Flex Pipe, Diesel Particulate Filter (DPF) Inlet  
VN**SP 252-030, Flex Pipe, Diesel Particulate Filter  
(DPF) Inlet**

(February 2014)

W2087509

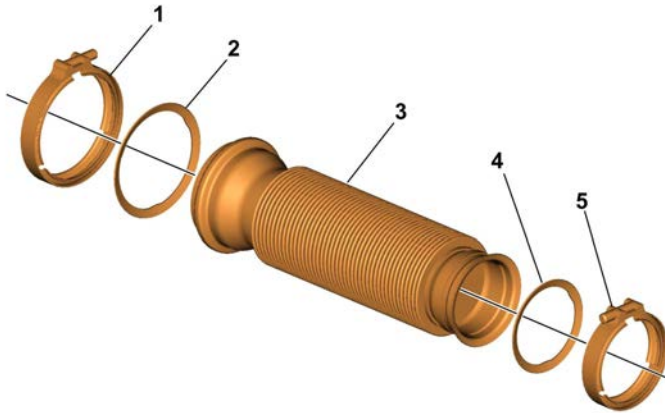
Volvo Trucks has established that the fiber layer found in the flex pipe between the DPF and the engine turbocharger with Cummins ISX engines can deteriorate under certain conditions and may be drawn into the exhaust stream leading to a plugged DPF. A new flex pipe design has been released to address this issue and to increase the durability of the flex pipe. This campaign only covers the replacement of the flex pipe for vehicles built between April 1, 2013 and January 10, 2014.

- 7 Remove flex pipe, gaskets and V-band clamps.
- 8 Clean all gasket sealing surfaces.
- 9 Loosely install the new gaskets, flex pipe and V-band clamps. Align flex pipe before tightening clamps.

**Note:** Flex pipe **MUST** be installed as straight and parallel to the engine turbocharger outlet pipe and DPF inlet pipe as possible. Flex pipe should NOT be installed in a curved manner.

**Note:** DO NOT, pry on, excessively bend, flex or twist the flex pipe to install. Failure to follow these guidelines may lead to premature failure of the flex pipe.

**Note:** Loosen the engine turbocharger outlet pipe and adjust as needed to achieve correct alignment of the new pipe.

- 10 Tighten V-band clamps to  $8 \pm 2$  Nm ( $70 \pm 18$  in-lb).
- 11 Start engine. Check for exhaust leaks.
- 12 Install the right side splash shield/inner fender.
- 13 Install the right chassis side fairing if removed.
- 14 Close and latch the hood.
